To: **Planning Reps**
From **Highways Development Management Officer**

Your Ref 20211121

Location 1 Codrington Gardens Gravesend Kent DA12 5DB

Design and Access Statement Photo.

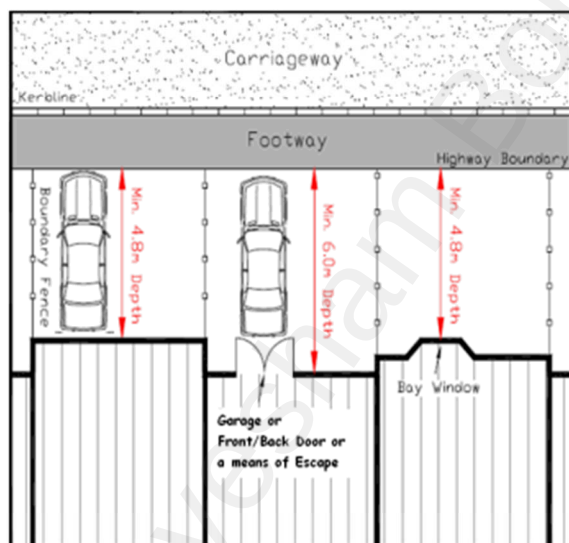
The Design and Access statement also shows the carriage crossover with the access not having the benefit of pedestrian visibility splays and the drive appears to be constructed from loose stone, but possibly a bound gravel. If the drive is in loose stone, both are not acceptable in highway terms as the lack of a pedestrian visibility splay puts pedestrians at risk, whilst a loose stone construction runs the risk of materials being dragged onto the highway.

Approximate sight line requirement, (apologises for the quality of the drawing).

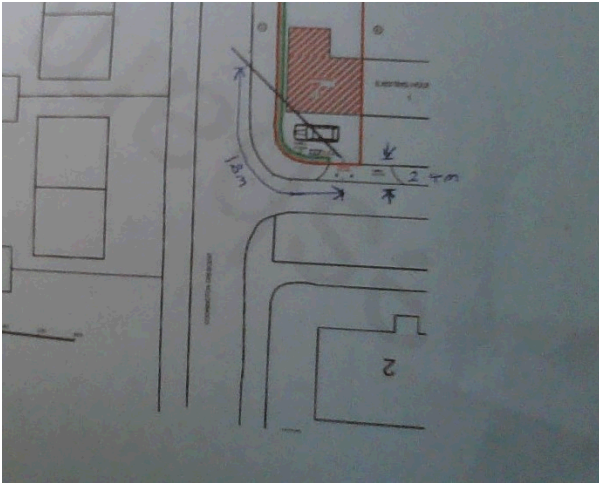
The proposed extended crossover is considerably closer than ten metres. In addition being a new property its parking provision should conform to current guidance, which requires the parking to be perpendicular to the highway

In addition vehicular visibility splays would be required which may be less than those required for 30mph speed limit due to the speed limiting corner radii towards the through traffic section of

Codrington Gardens. Assuming 15mph, the sight line requirement would be 18m along the kerb line from the centre of the access with a set back of 2.4 metres for the initial point, it is possible that meeting such a requirement would require the repositioning of the proposed dwelling.

As presented I would recommend refusal, as the proposed carriage crossover and parking area does not meet the requirements of the Highway Authority and as such cannot be provided. This in turn means the property does not benefit from off street parking, which whilst not in contradiction to Gravesham Borough Council's guidance is in conflict with The Highway Authority's adopted guidance, which postdates Gravesham's SPG and better reflects current practice of not setting minimum car parking provision at residential dwellings.
